Our Ref: R/2019/17/B and R/2017/22/F
File No: SSD 10376 and SSD 8876

RTS - Pitt Street South Over Station Development Stage 2 – SSD 10376 (Detailed Design) and SSD 8876 Mod 2 (Concept DA).

Figure 1: Windows discussed above

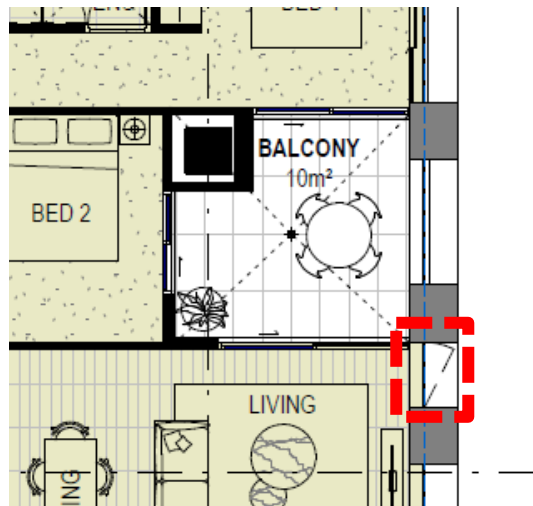
The applicant's RTS report (page 50) and Section 4.2 (page 32) does not specifically address the City's concerns with ventilation to the living rooms as previously raised. The specific windows of concern are outlined in Figure 1 below. As outlined before, due to the deep reveal within 2m of the opening the window would be unlikely to provide adequate ventilation. The design of the window should be amended so that the maximum natural ventilation possible can be achieved.
